SIB 13 02 20 NEW OPTIMIZED TORQUE SOFTWARE

2020-08-27

E-Series	Model Description	Production Date
K67	S 1000 RR	MY2020 and later

Main noise emission control
information label (7 924 038).

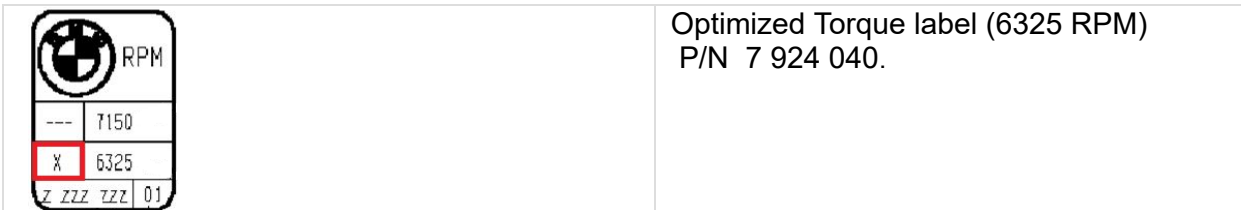
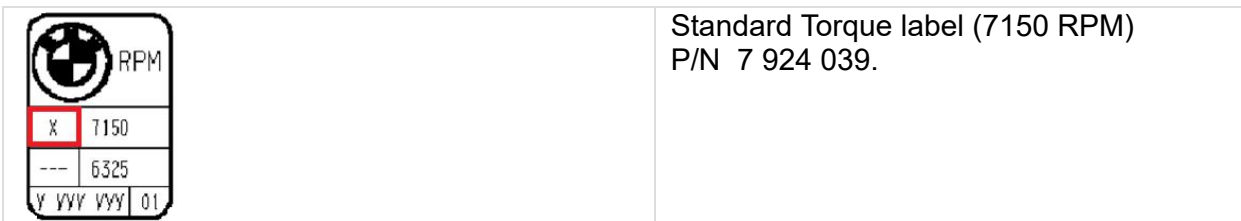
For the first retrofit of the torque optimized software, a new main noise emission control information label (7 924 038) must be applied over the original factory label.

Additionally, a smaller label (shown below) must be fixed next to the main noise emissions control information label showing the current programming status of the vehicle.

If the vehicle software is changed again, only the small label must be updated each time to reflect the programming status (version) of the vehicle.

<p>Standard Torque label (7150 RPM) P/N 7 924 039.</p>
	<p>Optimized Torque label (6325 RPM) P/N 7 924 040.</p>
